SOLICITATION ADDENDUM NO. 1
ITB 20-0038
Aloha High School Modular Roof Replacement

ADDENDUM #1 TO CONTRACT DOCUMENTS FOR:

BEAVERTON SCHOOL DISTRICT
ALOHA HIGH SCHOOL
MODULAR ROOFING

05/05/2021

1 ROOF PLAN - MODULAR
1/8" = 1'-0"

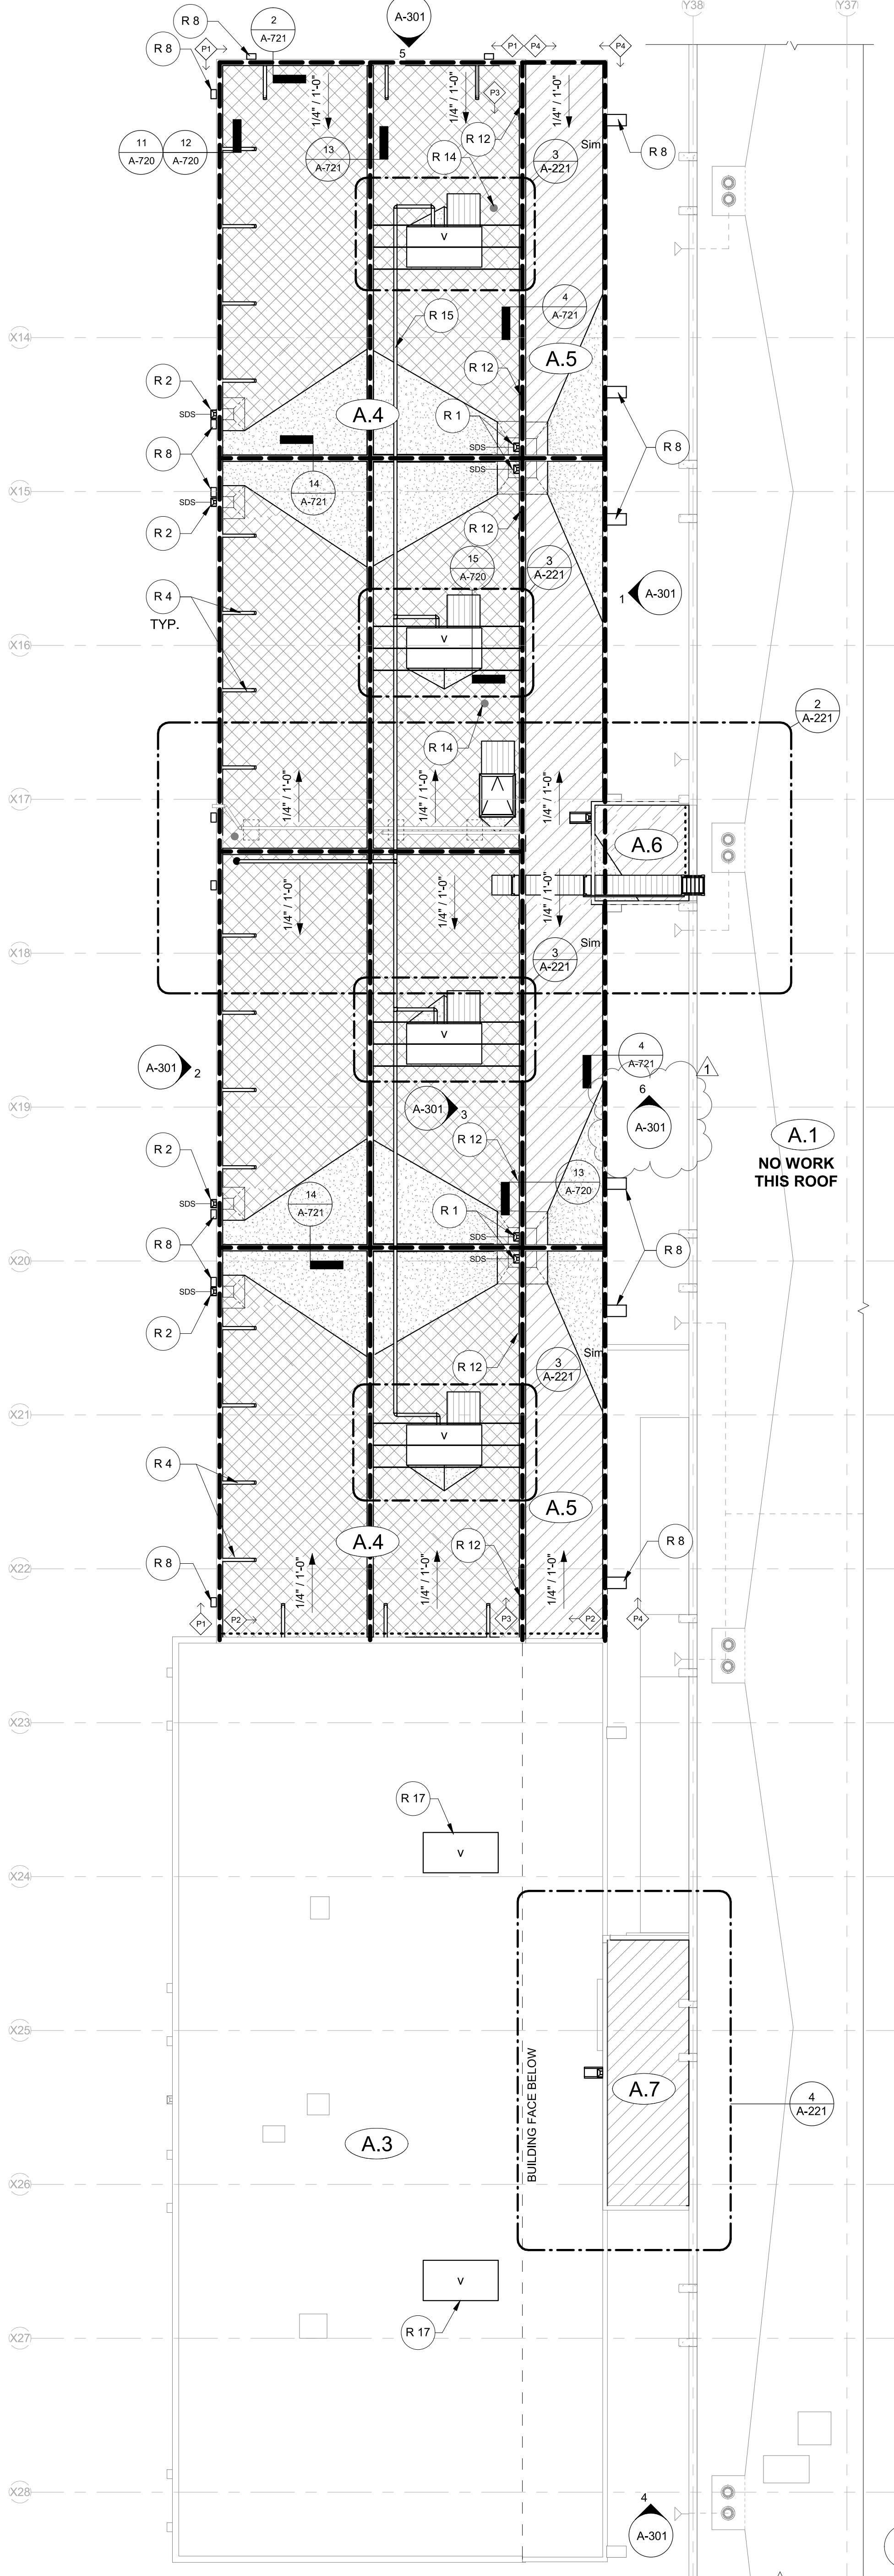
1. Sheet A-221:
 - a. **ADD** Elevation tag to 6/A-301
2. Sheet A-301:
 - a. **ADD** Elevation #6, "A6 ENLARGED SECTION"
 - b. **ADD** Keynote X8 to elevation #2
 - c. **ADD** Keynote X7 to elevation #3
 - d. **ADD** Keynote X8 to elevation #5
3. Sheet A-721:
 - a. **ADD** Detail #21 to show rail connection to (E) ladder
 - b. **REVISE** Detail #17 to show structural elements
 - c. **REVISE** Detail #18 to show structural elements
 - d. **REVISE** Detail #20 to show structural elements
